**July 18, 2016**  
**BOARD OF COUNTY COMMISSIONERS**  
**ORANGE COUNTY, FLORIDA**  
**Y16-787 / ADDENDUM #1**  
**ORANGE COUNTY CONVENTION CENTER**  
**NORTH / SOUTH BUILDING SHOW POWER UPGRADES**

**Bid Opening Date: July 26, 2016**

**2** SOUTHWEST PENTHOUSE SECTION  
1/4" = 1'-0"

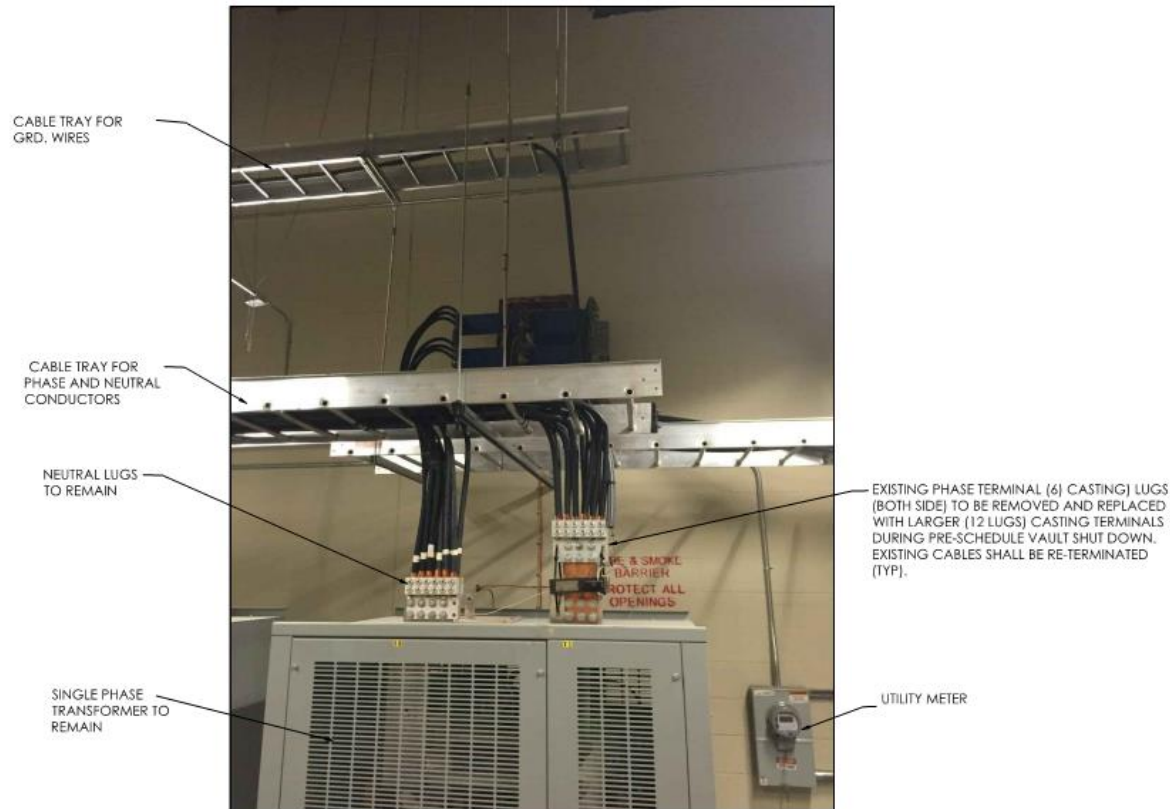
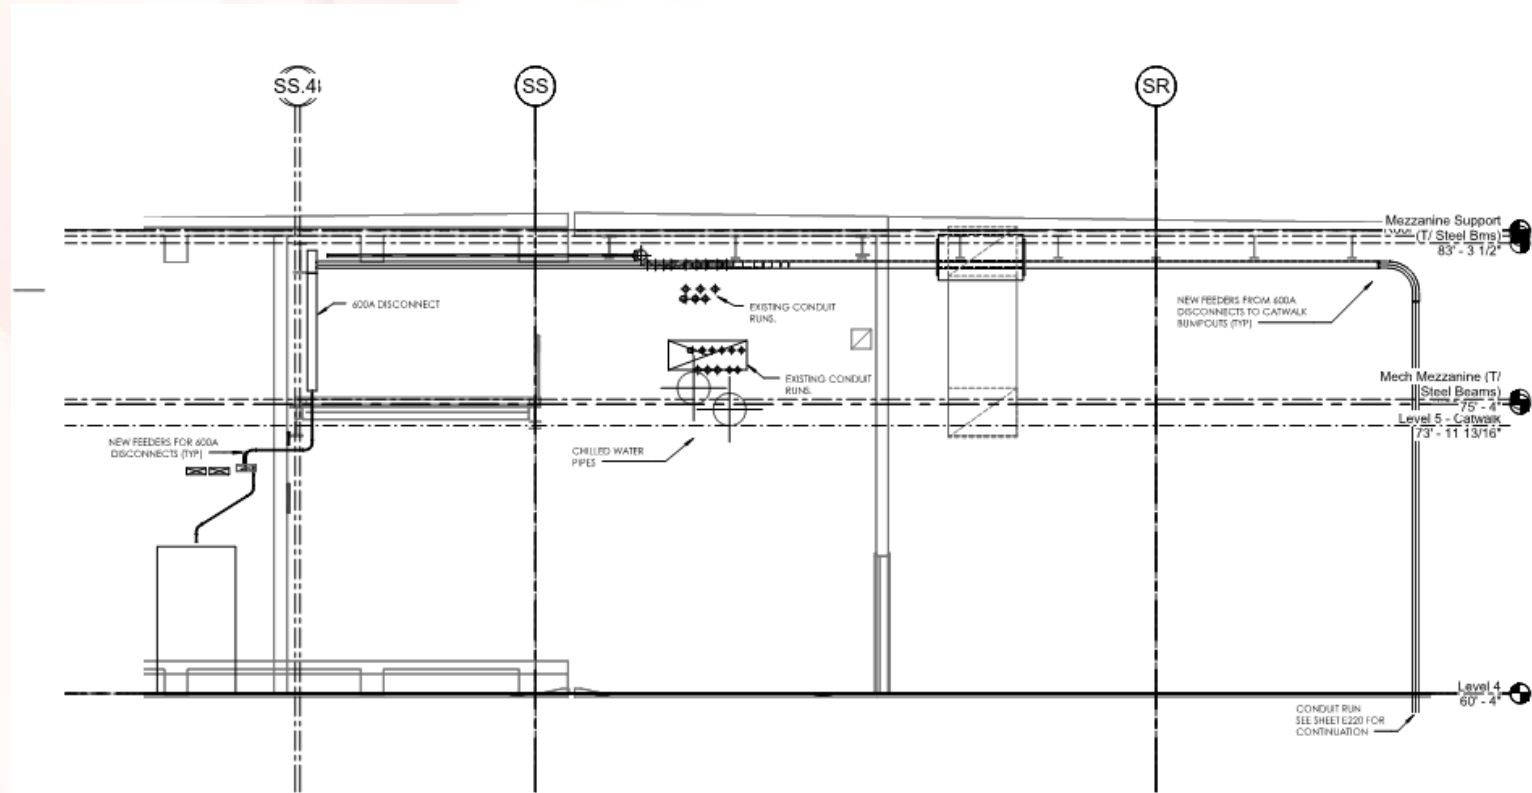
- **(9) New services at each location in the mezzanine**
- **Heavy coordination with OUC transformer vault.**

- (9) New services at each location in the mezzanine
- Route conduits across penthouse, add expansion joint fittings at crossings
- Core drill/ route down to floor below into high ceiling of show floor/ catwalk area
